RE: 5046 Valle Del Sol Rd. NW
Grading and Drainage Plan
Engineer's Stamp Date: 11/06/18
Hydrology File: J11D038

RE: 5046 Valle Del Sol Rd. NW
Grading and Drainage Plan
Engineer's Stamp Date: 09/07/18
Hydrology File: J11D038

Based upon the information provided in your submittal received 09/10/2018, the Grading Plan is **not** approved for Building Permit. The following comments need to be addressed for approval of the above referenced project:

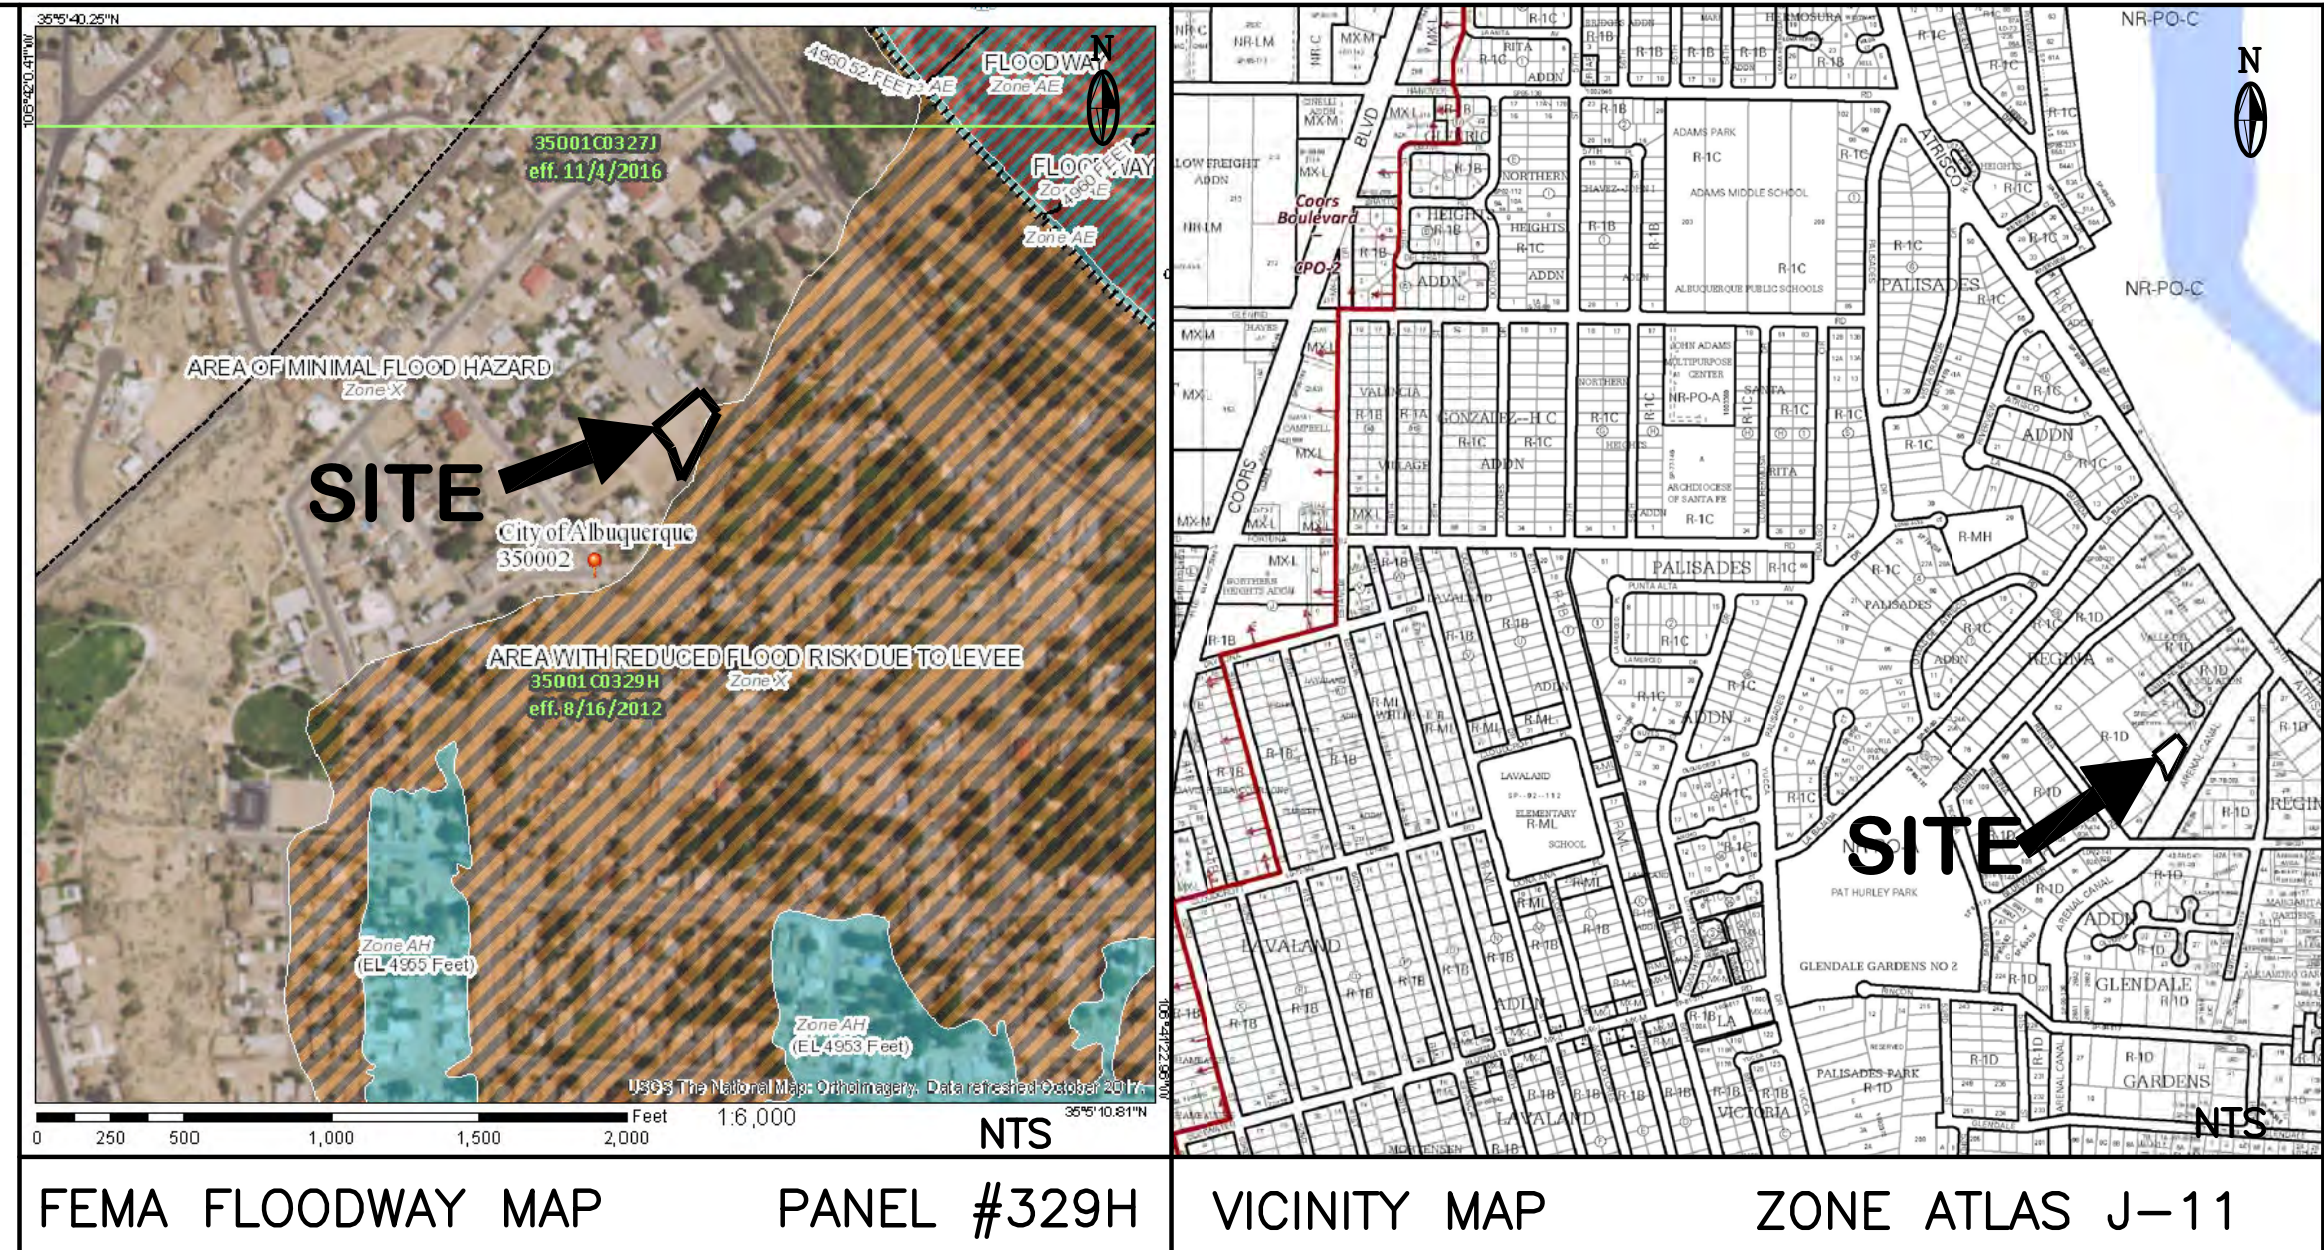
1. Currently the design does not follow the Flat Grading Scheme outlined in the DPM. Please follow Chapter 22 Section 5.G (Flat Grading Scheme). The following conditions must be applied to the site:

- a. The maximum percent impervious of the lot and the contributing area may not be greater than 45%. **The site meets this requirement.**
 - b. Pad elevation shall be a minimum of one (1) foot above the 100 year 10-day storm water surface elevation. **The finished floor of the main level is 6 feet above existing grade and the basement is 10' below main level.**

- c. The flow between the front yard and back yard cannot be obstructed. The storm water must be allowed to equalize to the same level between the front yard and back yard. **Note has been added.**

- d. A permanent perimeter wall or barrier around the development is required to contain the 100 year 24 hour storm developed runoff. **Note has been added.**

- e. The high point of the street should be four inches above the 100 year 10-day storm water surface elevation. **Note has been added.**
2. Also a retention pond is required. The required volume = (3.67 in. X impervious area / (12in/ft)). The location with elevation of pond and the calculation of both the required and actual volume needs to be shown on the Grading Plan. **Note has been added.**

3. Please place gravel and slope the hammer head on this project's property at least. Transportation may want the entire hammer head built. This is for the Fire Department. The area of this graveled hammer head needs to be included in the Type C soil in the calculations. **Note has been added.**

TRANSPORTATION MAY WANT THE ENTIRE HAMMER HEAD BUILT. THIS IS FOR THE FIRE DEPARTMENT. THE AREA IS INCLUDED IN THE TYPE C SOIL IN THE CALCULATIONS.

PROVIDE GRAVEL AND SLOPE THE HAMMER HEAD ON THIS PROJECT'S PROPERTY.

THE HIGH POINT OF THE STREET SHALL BE 4" ABOVE THE 100 YEAR, 10-DAY STORM WATER SURFACE ELEVATION (4959.0).

THE FLOW BETWEEN THE FRONT YARD AND BACK YARD CANNOT BE OBSTRUCTED. THE STORM WATER MUST BE ALLOWED TO EQUALIZE TO THE SAME LEVEL BETWEEN THE FRONT YARD AND BACK YARD.

PROVIDE A PERMANENT PERIMETER WALL OR BARRIER (BERM) AT ELEVATION 4960.0 AROUND THE DEVELOPMENT TO CONTAIN THE 100 YEAR 24 HOUR STORM DEVELOPED RUNOFF.

A RETENTION POND IS REQUIRED TO PROVIDE THE VOLUME = (3.67 IN * IMPERVIOUS AREA) / (12 IN/FT) = 799 CF (MIN.) THE LOCATION WITH ELEVATION OF POND AND THE CALCULATION OF BOTH THE REQUIRED AND ACTUAL VOLUME IS SHOWN ON THIS PLAN.
